DOE/EA – 1492

**ENVIRONMENTAL ASSESSMENT
COMMENT RESPONSE, AND
FINDING OF NO SIGNIFICANT IMPACT**

Pond and Land Configuration

U.S. Department of Energy
Rocky Flats Project Office
Golden, Colorado

Figure 1-4. Rocky Flats Environmental Technology Site 100 Year Floodplain

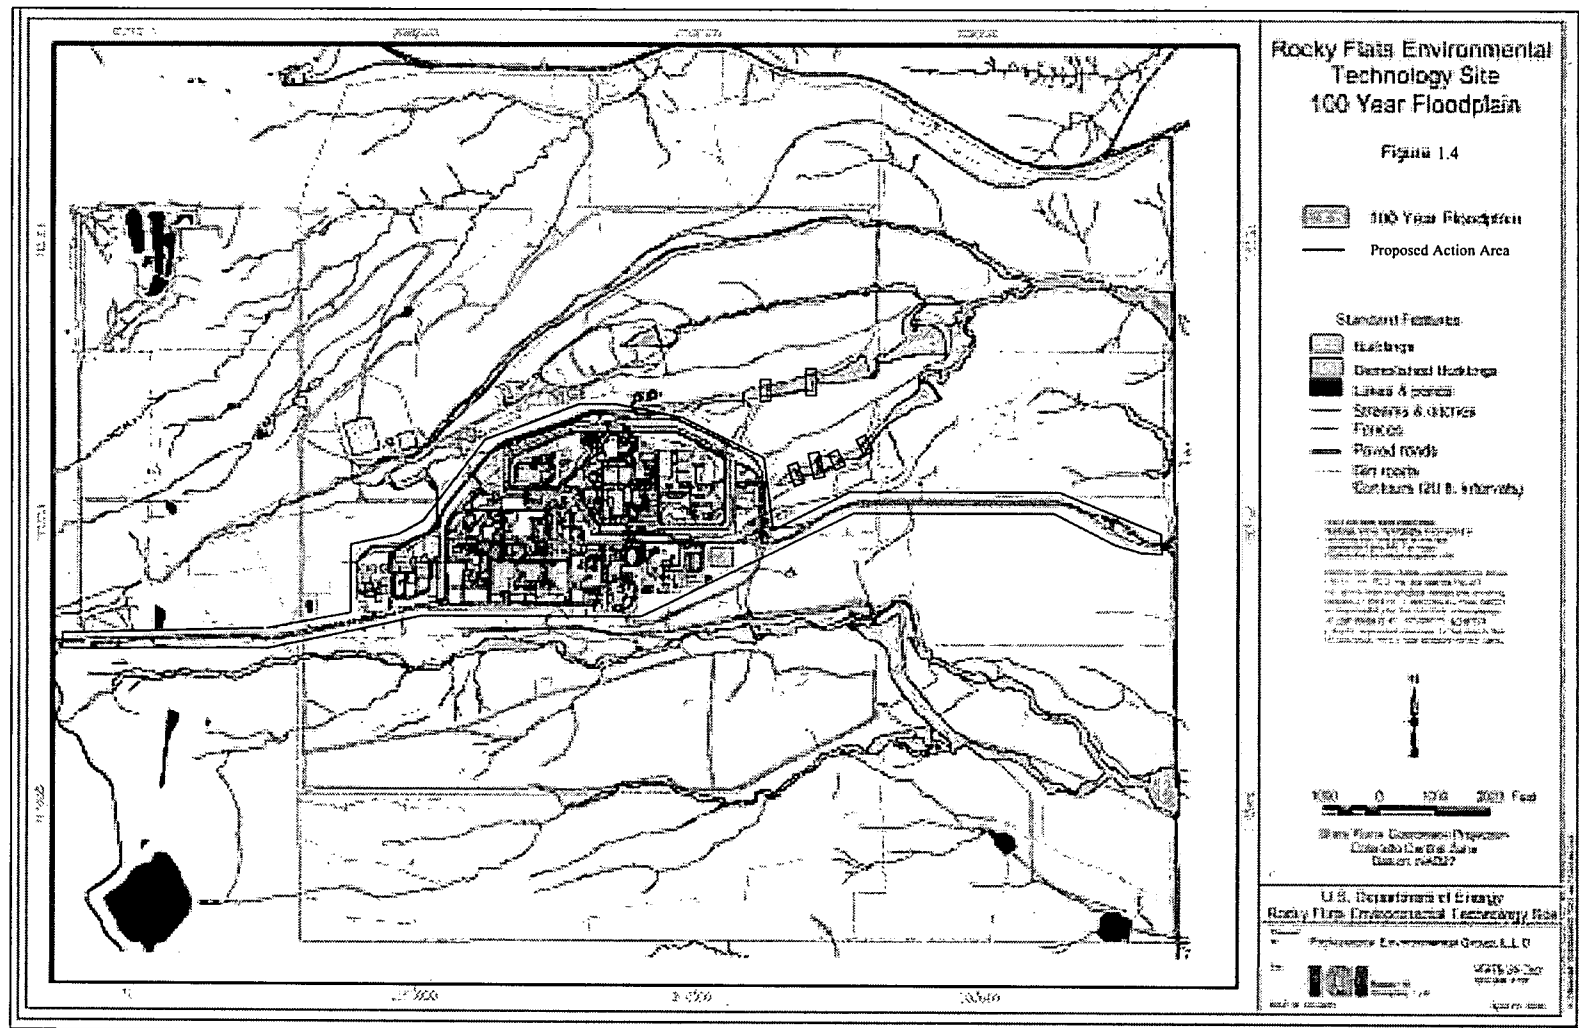
22.	There is a 100-year flood plain map on Page 8 of the document. The Board requests the Site provide the date of the map.	22	The date of the map in Figure 4-1 is included and is April 13, 2004.

Figure 2-2. Typical Front View of Modified Dam

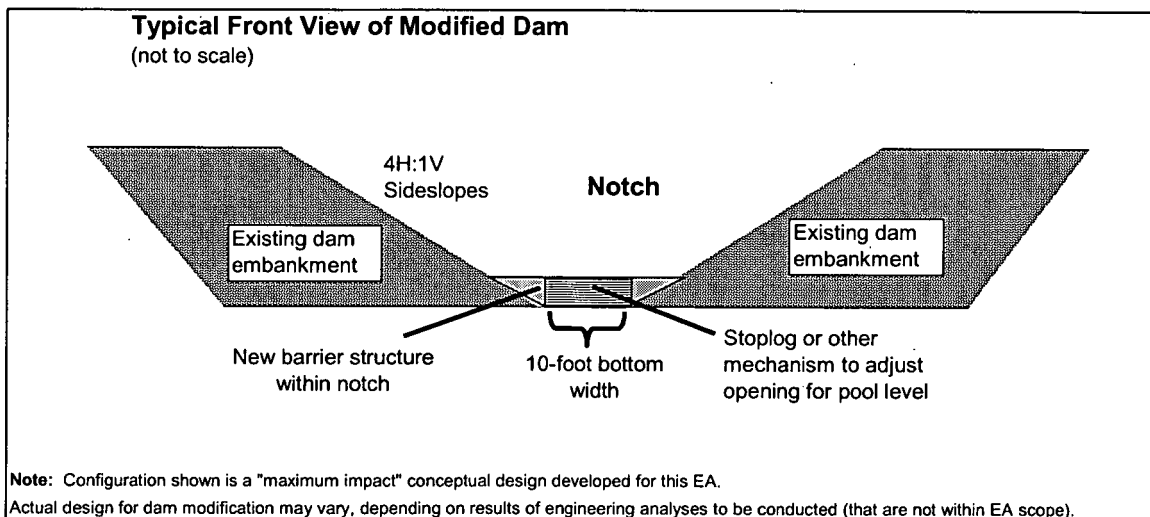
18.	The draft proposed action alternative states a <i>“notch” will be cut into each dam to reduce its effective height (Figure 2-2), thus creating a lower-profile.</i> Provide Broomfield with the process to disposition the removed soil from the dam and the characterization plan for the media.	17	Please refer to Responses to Groups of Similar Comments – Waste Characterization and Disposal.

Comment Number	Comment	Response Category	Response
22.	The draft proposed action alternative states a <i>“notch” will be cut into each dam to reduce its effective height (Figure 2-2), thus creating a lower-profile.</i> We understand the design is conceptual at this stage and the invert elevation of the notch would be the same as the pond bottom elevation. We also understand the actual design for the dam modifications may vary, depending on the results of engineering analysis. The EA states the engineering analysis is not within the scope of the EA, yet it is a crucial aspect of the proposal. Provide Broomfield with the objectives for the engineering analyses. Also identify the document that will contain the engineering analysis.	10, 24	Please refer to Responses to Groups of Similar Comments – Exclusion of Detailed Infrastructure and Operations.

Figure 3-1. IA Grading and Drainage Plan

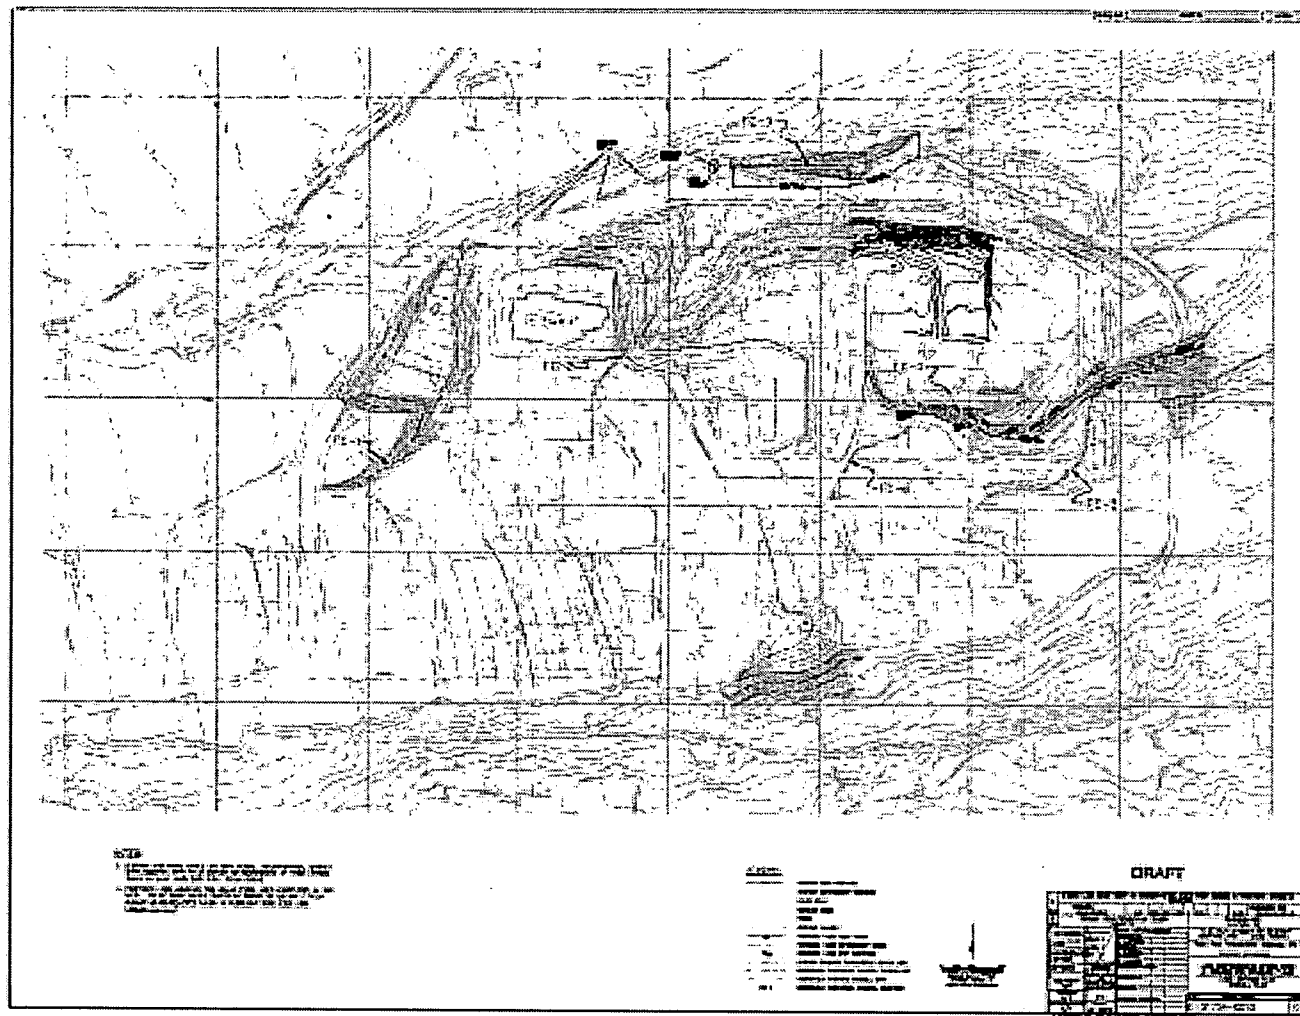
17.	Figure 3-1, IA Grading and Drainage Plan: CDPHE has not yet concurred with the final land configuration for the Industrial Area (IA). The figure presented is adequate for general discussion, but some important configurations may be modified in the final version.	9	DOE-RFPO understands that the IA Grading and Drainage Plan has been referenced in the EA for general discussion, and specific land configuration design may change from the referenced version of the document.

23.	§3.1.4.1, Page 22, We have not seen the “IA Land Configuration Concept Design Grading Plan (Revision 1, March 2004) (K-H, 2004a)”. Please provide us a copy in order to evaluate this section.	9	The referenced grading plan was included in the draft EA (Figure 3-1).

25.	§3.1.4.3, Page 23, As stated above, we have not seen the “IA Land Configuration Concept Design Grading Plan (Revision 1, March 2004) (K-H, 2004a)”. Revise the document to identify the location and number of channels needed (provide a map) and potential types of erosion controls that may be utilized.	9	The referenced grading plan was included in the draft EA (Figure 3-1).

27.	Figure 3.1, Page 27, The included map is useless. One cannot ascertain anything from what is provided. Add a larger, more readable map to the document.	25	Comment Noted.

12.	How will the drainage be changed around Buildings 371/374? Do we really want natural drainage around the contaminated basements and groundwater plume?	9	The grading around B371/374 is shown on the conceptual grading plan as referenced in the draft EA (Figure 3-1).
